From: WILLIFORD Dennis (AREVA) [Dennis.Williford@areva.com]
Sent: Wednesday, June 29, 2011 4:34 PM
To: Tesfaye, Getachew
Cc: BENNETT Kathy (AREVA); DELANO Karen (AREVA); ROMINE Judy (AREVA); RYAN Tom (AREVA); HOLM Jerald (EXTERNAL AREVA)
Subject: Response to U.S. EPR Design Certification Application RAI No. 432, FSAR Ch. 15, OPEN ITEM, Supplement 7
Attachments: RAI 432 Supplement 7 Response US EPR DC.pdf

Request for Additional Information No. 432(4958), Revision 1, Supplement 7

U.S. EPR Standard Design Certification

SRP Section: 15.00.02 - Review of Transient and Accident Analysis Methods

Sheet 2 of 2

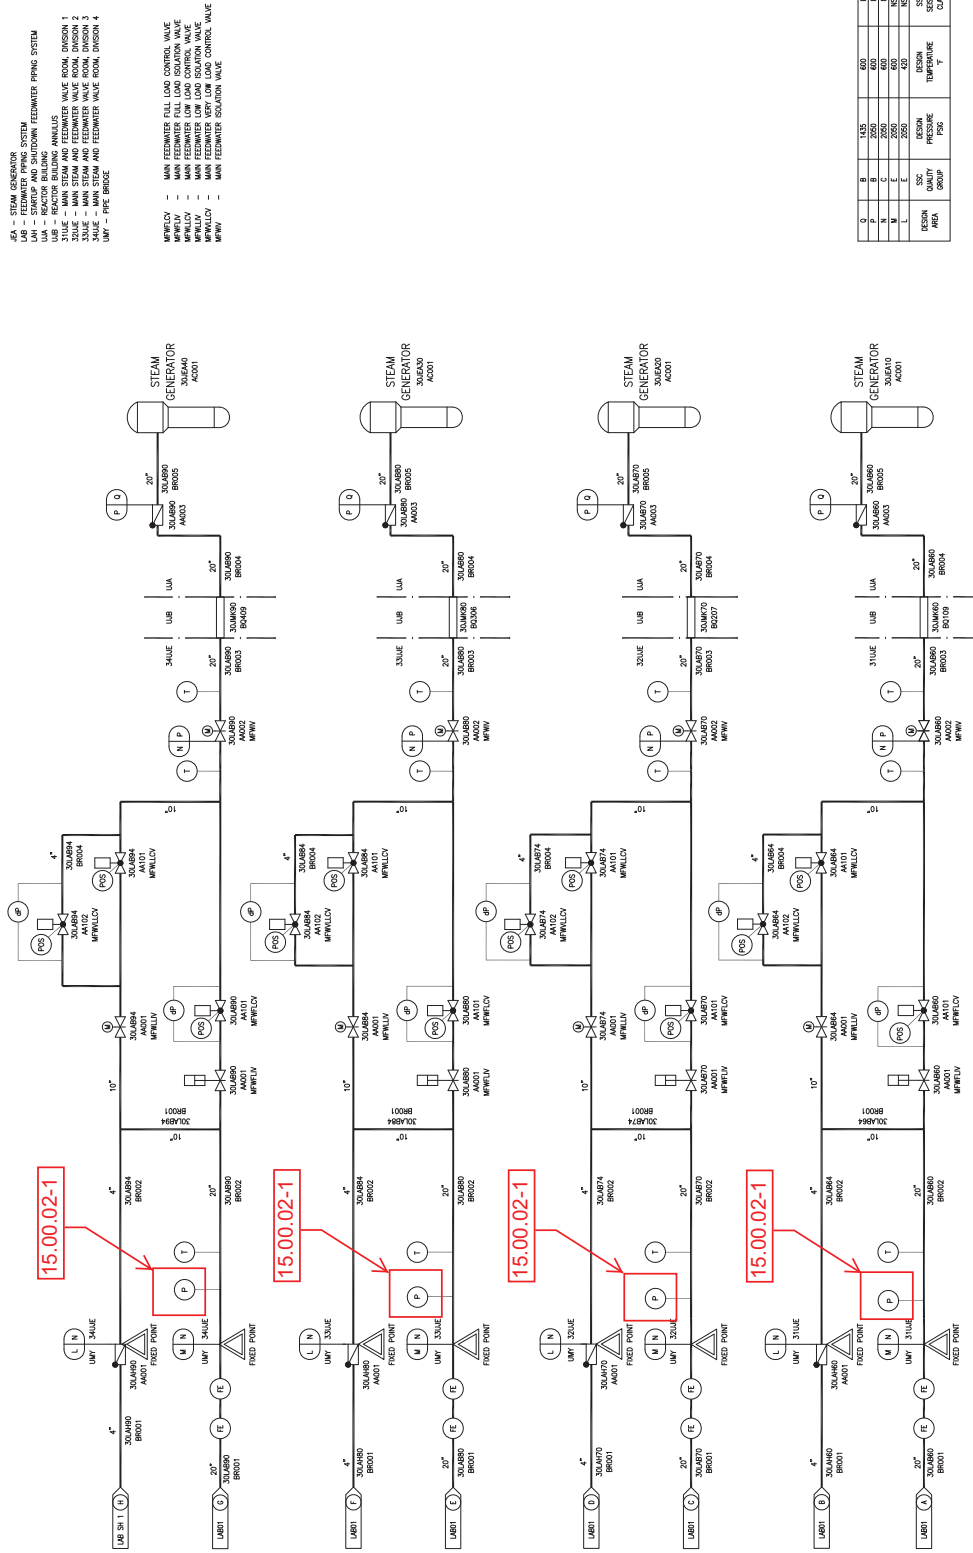
However, EPR FSAR Revision 1 does not provide sufficient information of the instrumentation and/or methodology for the main feedwater flow measurement, nor provide a basis for the statement that the main feedwater flow measurement supports a 0.48% power uncertainty.

- ◆ Feedwater flow rate for each train of feedwater (refer to U.S. EPR FSAR Tier 2, Section 10.4.7.5 and Figure 10.4.7-1).
- ◆ Feedwater temperature for each train of feedwater (refer to U.S. EPR FSAR Tier 2, Section 10.4.7.5 and Figure 10.4.7-1).
- ◆ Feedwater pressure for each train of feedwater. U.S. EPR FSAR Tier 2, Figure 10.4.7-1 will be revised to show the pressure sensors.
- ◆ Steam generator (SG) blowdown flow rate for each SG (refer to U.S. EPR FSAR Tier 2, Figure 10.4.8-1).
- ◆ SG blowdown temperature for each SG (refer to U.S. EPR FSAR Tier 2, Figure 10.4.8-1).

U.S. EPR FSAR Tier 2, Table 1.8-2, Section 7.7.2.3.5, and Figure 10.4.7-1 will be revised as described in the response and indicated on the enclosed markup.

- Feedwater flow rate for each train of feedwater (refer to Section 10.4.7.5 and Figure 10.4.7-1).
- Feedwater temperature for each train of feedwater (refer to Section 10.4.7.5 and Figure 10.4.7-1).

- Feedwater pressure for each train of feedwater (refer to Figure 10.4.7-1).
- Steam generator blowdown flow rate for each steam generator (refer to Figure 10.4.8-1).
